RE: JACKSONVILLE ELECTRIC AUTHORITY
DEP FILE NOS. 0310045-027-AC & -028-AV
AIR CONSTRUCTION PERMIT AND TITLE V PERMIT REVISION APPLICATION
RESPONSE TO RAI DATED SEPTEMBER 23, 2009

Air Construction Permit Application, File Number 0310045-027-AC

Title V Air Operation Permit Revision Application, File Number 0310045-028-AV

LANDFILL GAS SAMPLING LOCATION PLOT PLAN

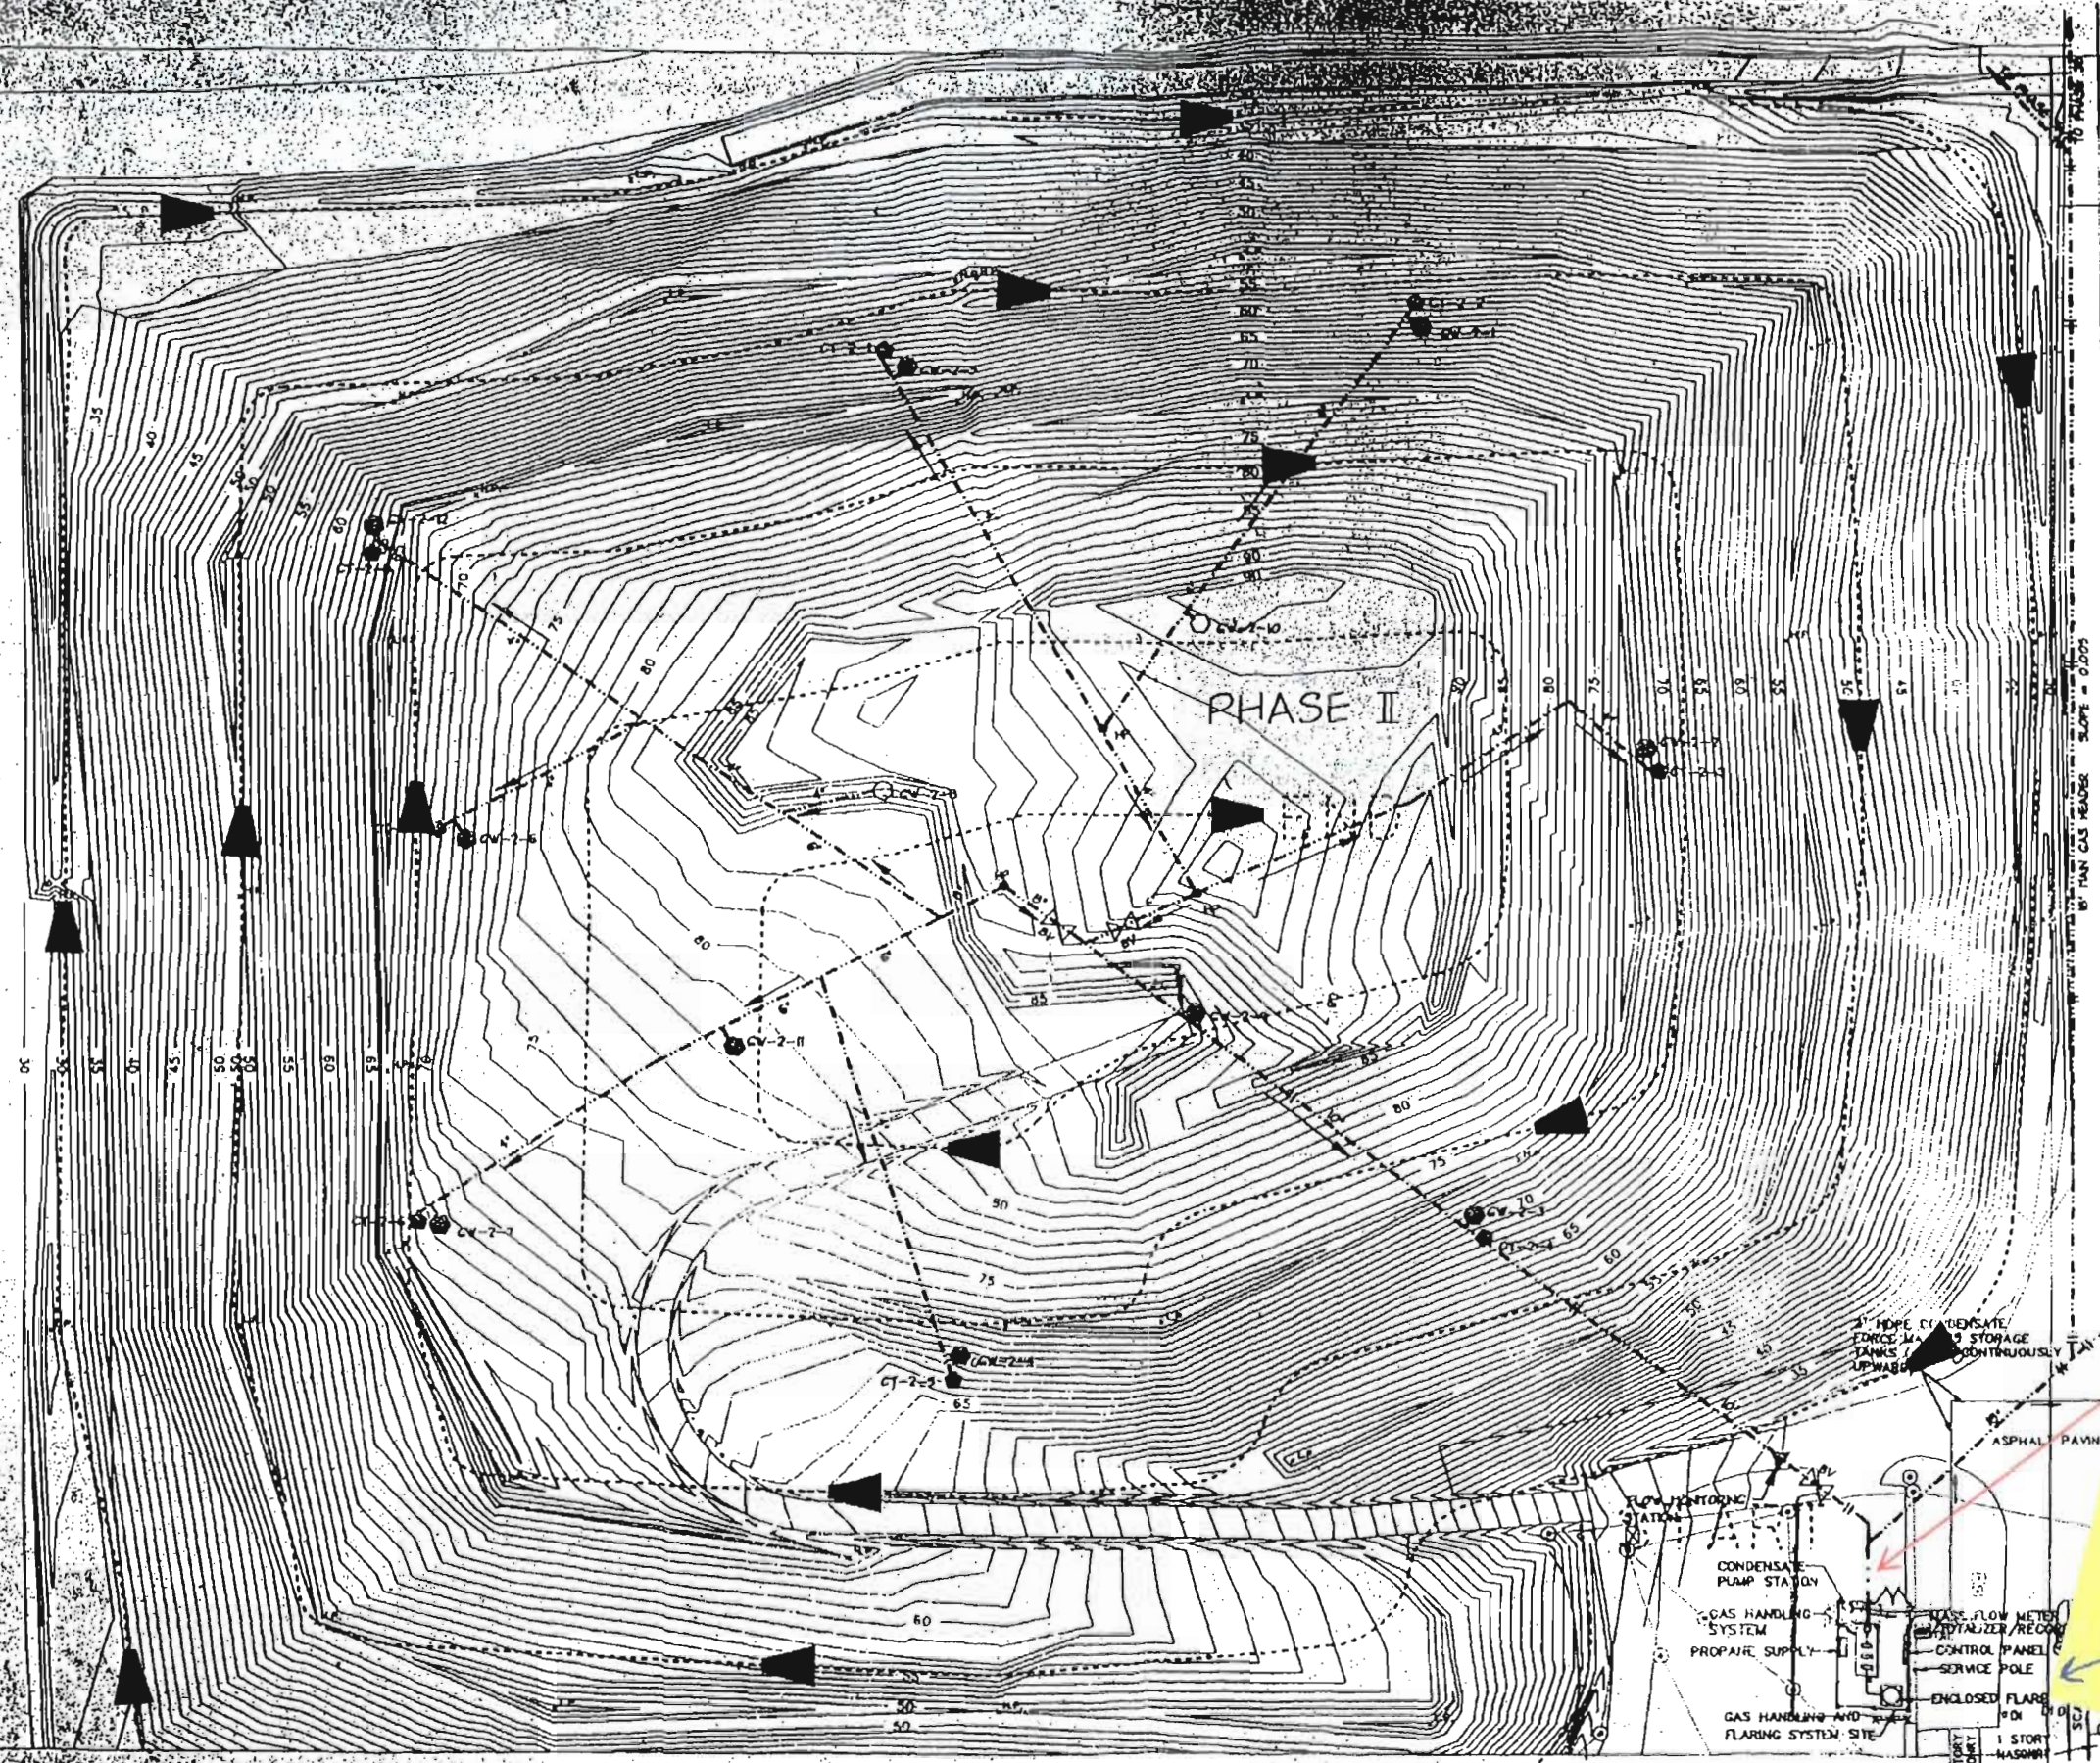
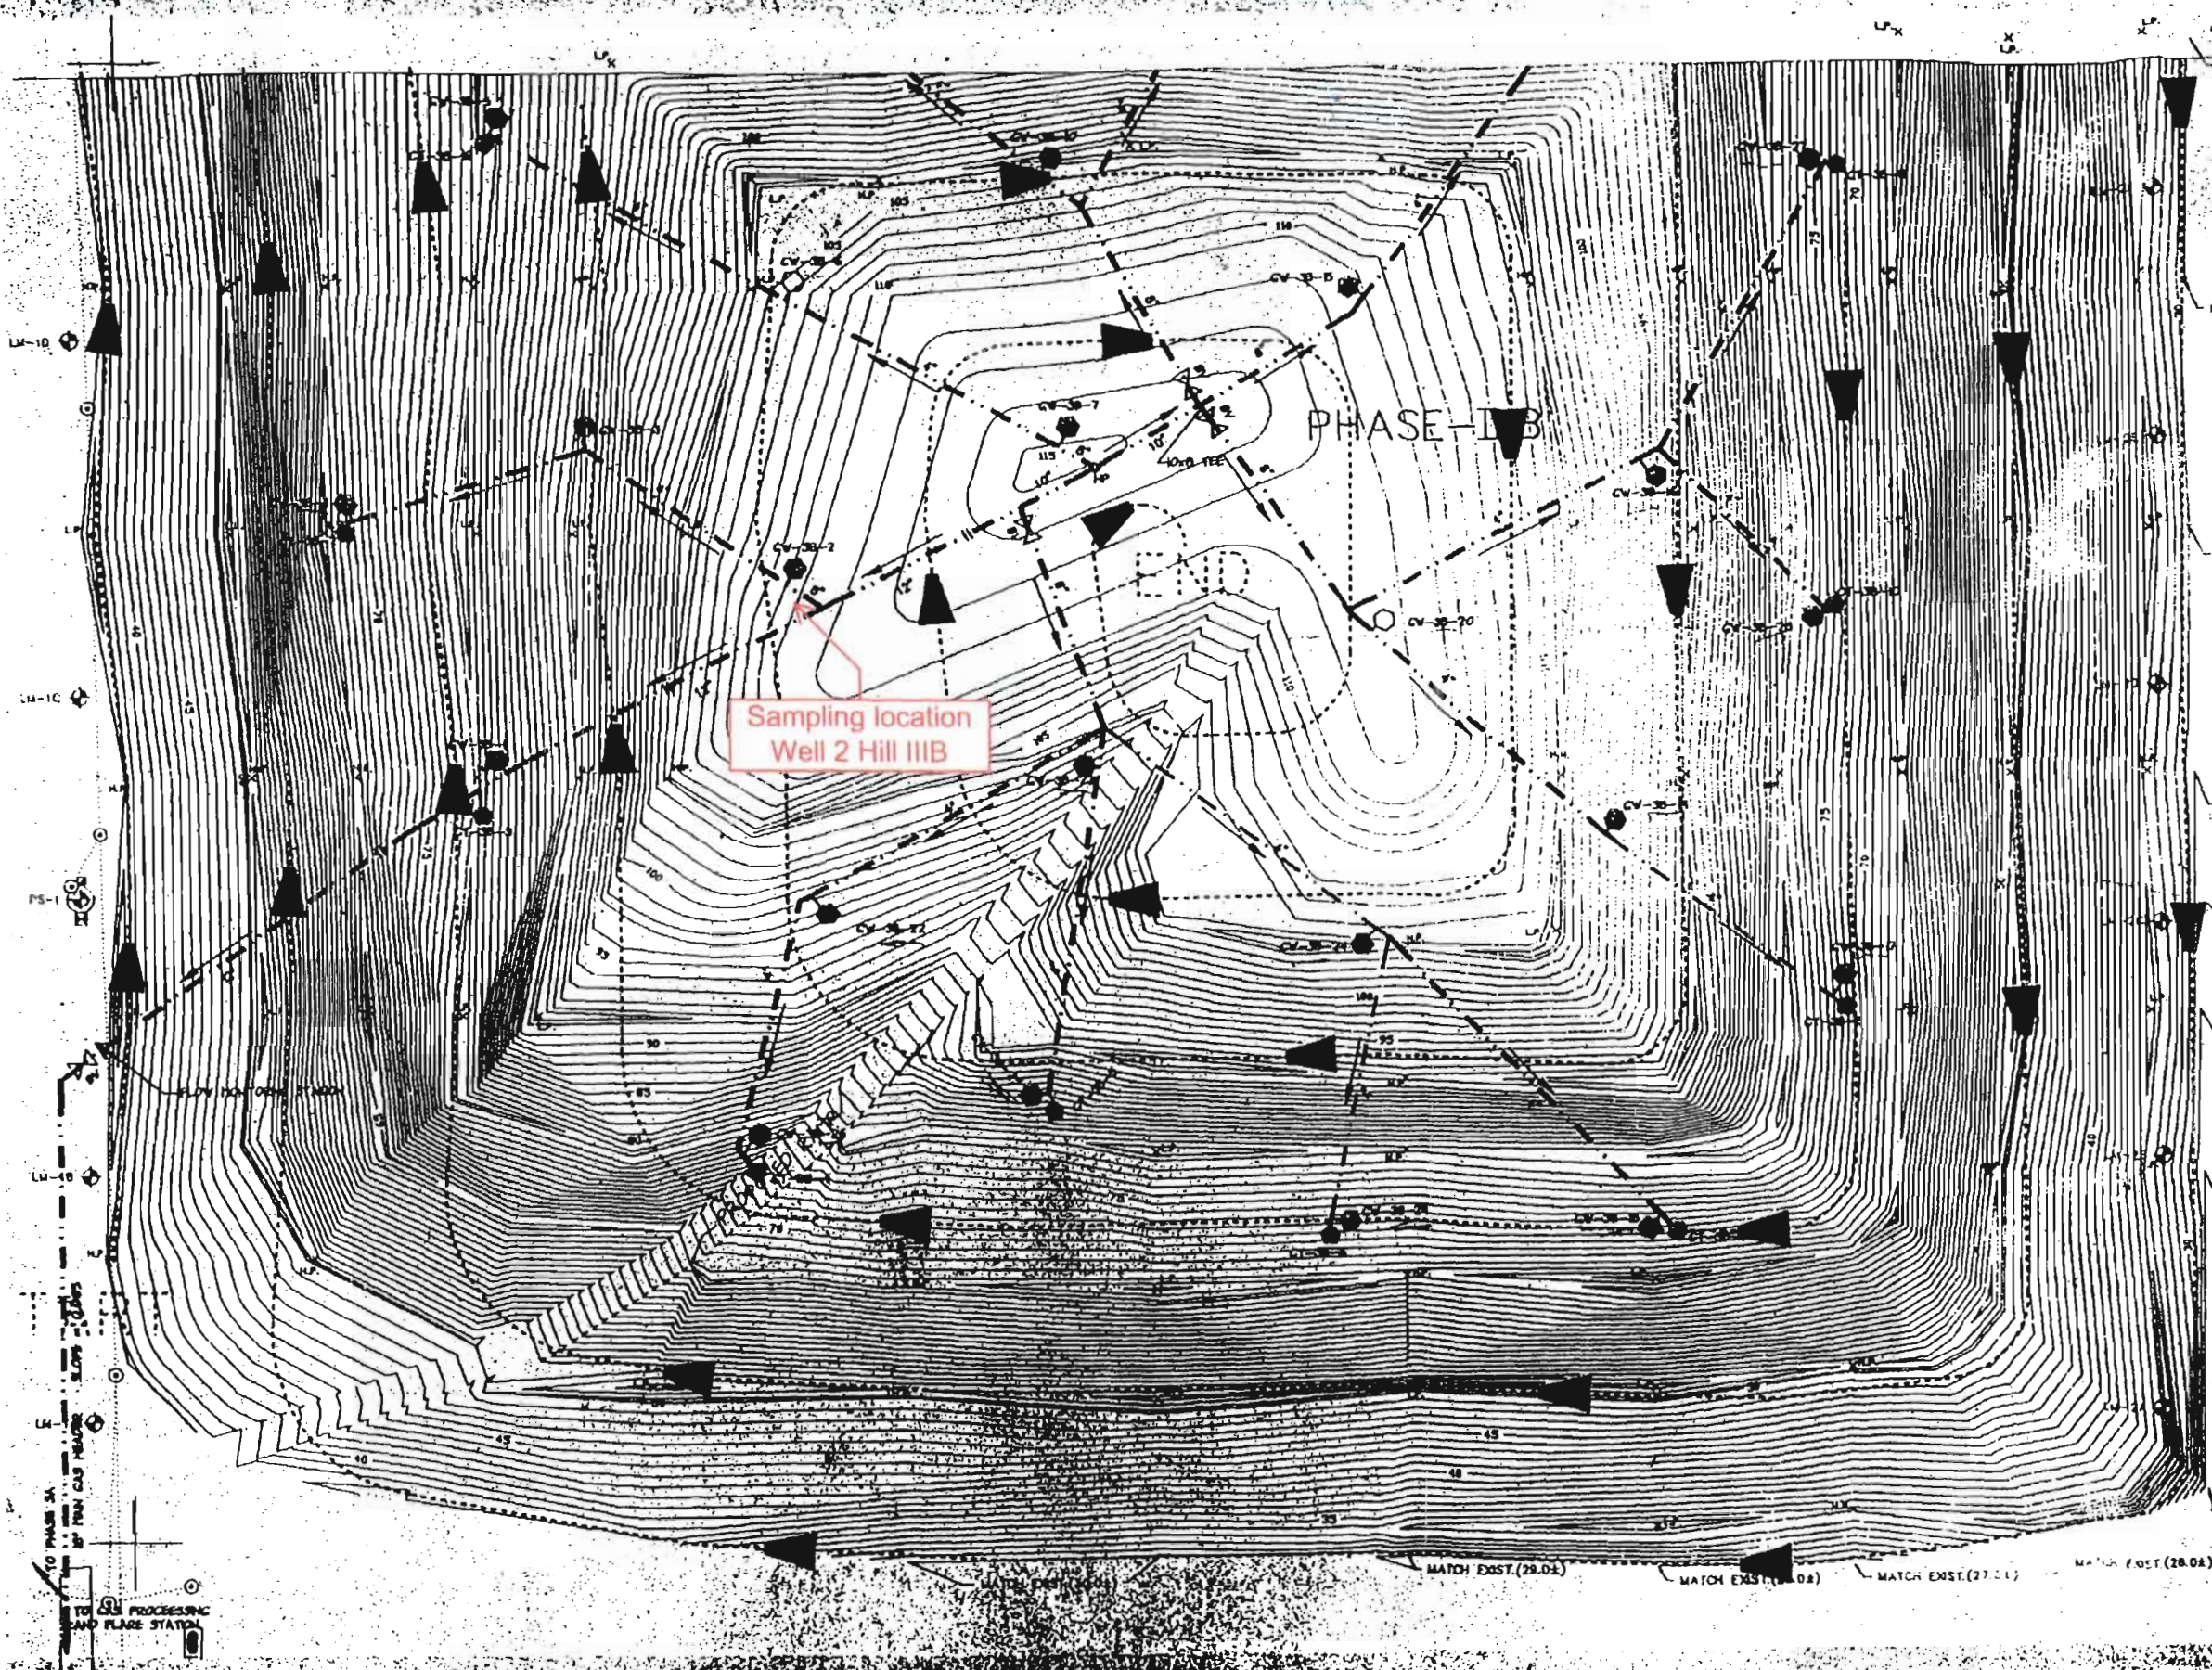
- c. In the attachment named "Attachment JEA-EU2-I2", Sample #1 indicates "before flare". Is there a flare on-site? Is the flare permitted? Who is the owner/operator of the flare and the landfill?

- d. In the attachment named "Attachment JEA-EU2-I2," a fuel analysis for a landfill gas is provided. The analysis indicates that two samples were taken. E.g., Sample #1 and #2. Sample #1 before flare indicates an H₂S content of 48.3 ppm using the GEM 200 analyzer method. Where physically were the Sample #1 and #2 taken at the landfill? A plot plan for the landfill was not found in the application. Please provide a plot plan showing the specific sample locations at the landfill. Also, what were the dates of the samples?

- c. An enclosed flare is located on-site at the landfill as a backup combustion device when the NGS Boiler No. 3 is unable to combust the landfill gas. The landfill is owned and operated by the Solid Waste Division of the City of Jacksonville. Permit No. 0310340-005-AV, issued on June 18, 2009, authorizes the use of the enclosed flare as an alternate method of operation.

- d. The landfill gas system operator for North MSW Landfill (Earth Tech) collected field samples before the flare and at Well No. 2 in Hill III-B on March 5, 2008. A plot plan of the landfill showing the specific sampling locations is attached (see Attachment 3).

Figure 4-2
North Landfill Model Curve

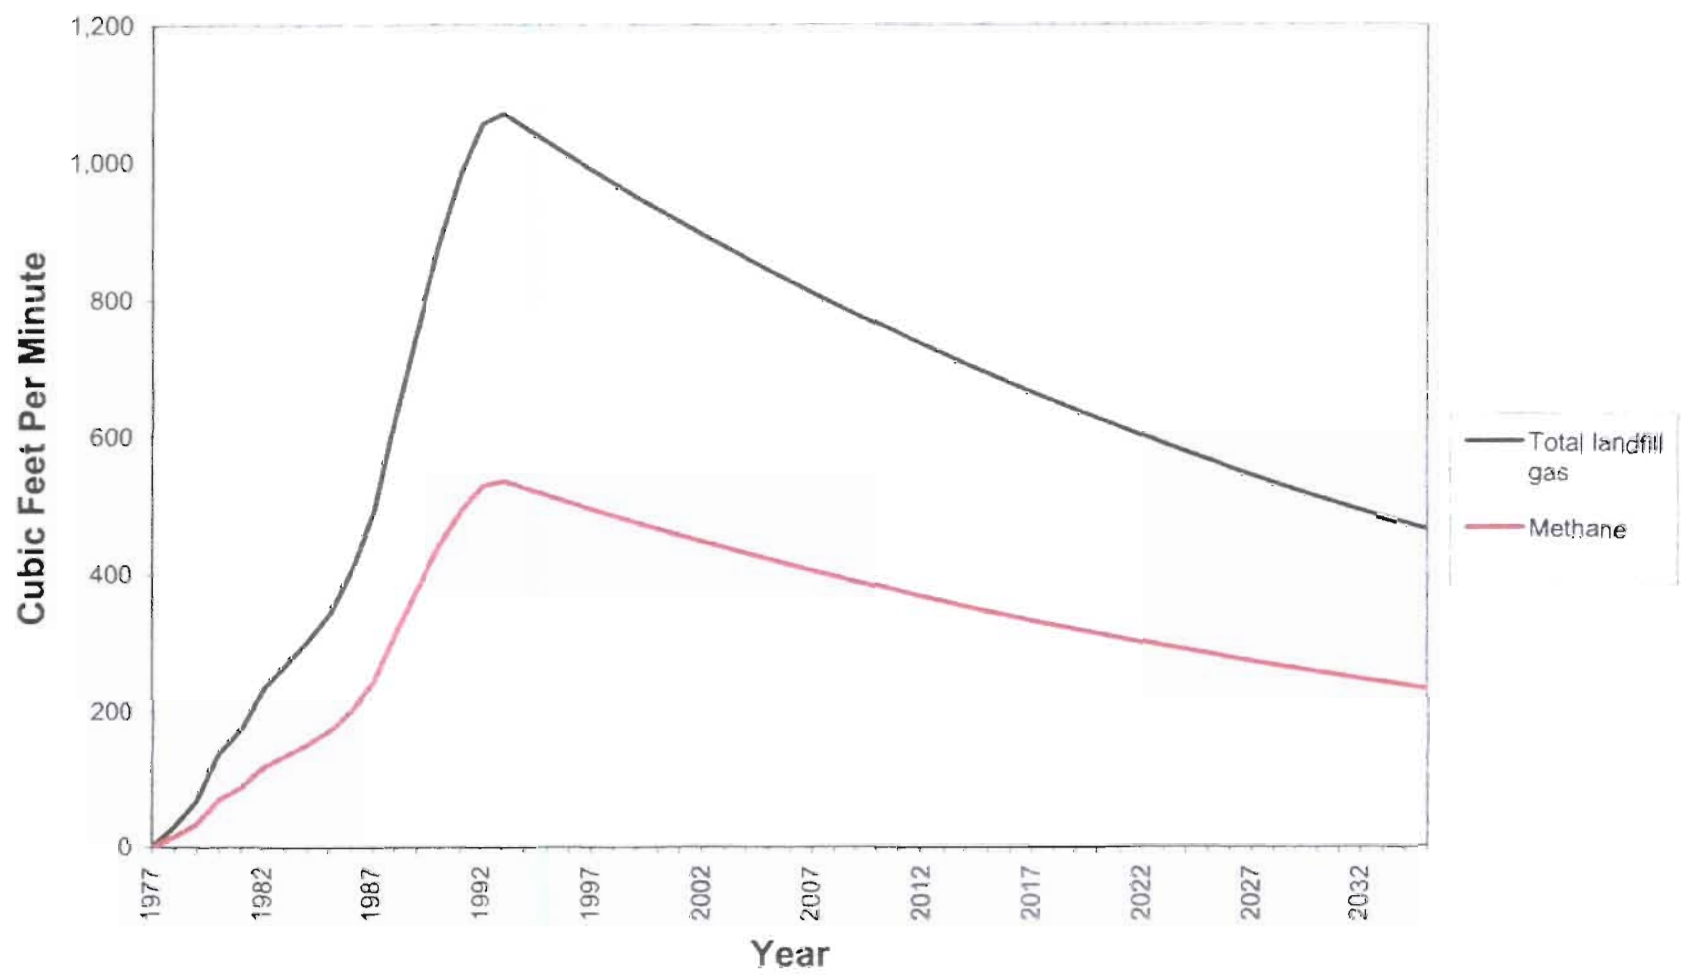
- e. Are there any plans to pretreat the landfill gas prior to being combusted in the boilers? If so, how?
- f. How long is the landfill gas supply expected to last, in years?

- f. Please refer to the gas curve generated by CDM in June 2008, where the gas production trends for the North MSW Landfill are shown. The graph projects landfill gas beyond 2032 (see Attachment 4).
- g. JEA is requesting to burn landfill gas in combination with the other permitted fuels in NGS CFB Boiler Nos. 1 and 2. The facility will continue to adhere to the current permit limits.
